**Reference: Hannan Hills Subdivision
Response to Second Submission Comment Letter
County File 09-T-21002
Our File: 118201**

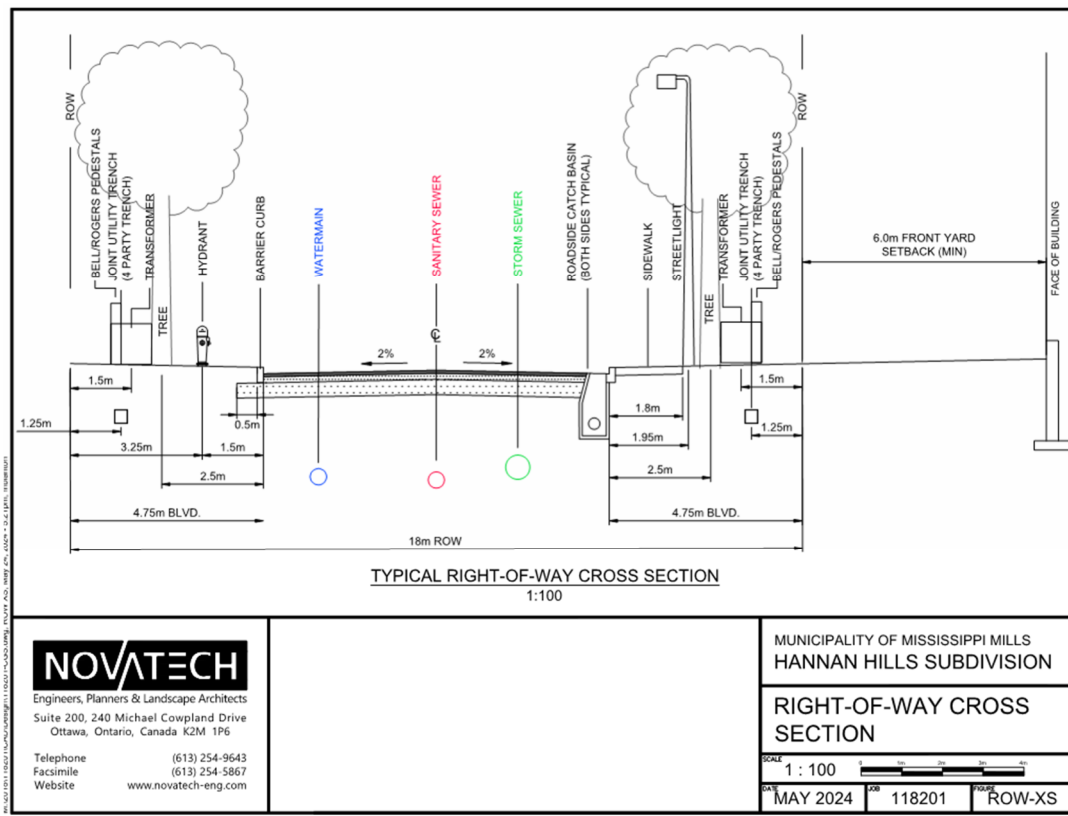
4. As noted in the Transportation Section below, right-of-way widths are proposed at 18 metres. Please amend Street One to a 20-metre right-of-way width. Based on the corner lot setbacks of Blocks and the large front yard setbacks of the for the back-to-back townhouses, there is area available to increase Street One to a 20-metre right-of-way width.

Novatech Response: **The 18m right-of-way remains on the revised draft plan. It is understood that an 18m right-of-way is acceptable, based on the following rationale provided in Novatech's earlier memorandum dated March 21, 2025:**

- The 18m cross-section included with the submission is shown below and demonstrates that the 18m width can meet both functional and operational requirements for servicing. The 18m cross-section accommodates the required sewers, watermain, hydrants, and utilities while still allowing for street parking, sidewalks and trees. Going from an 18m to a 20m cross section increases the pavement width to 9m and lengthens each driveway by 1m. The increase in paved areas negate the nominal increase in grassed boulevards area within the ROW for snow storage, in particular due to the ratio of driveways to lot frontage typical of a townhouse development.
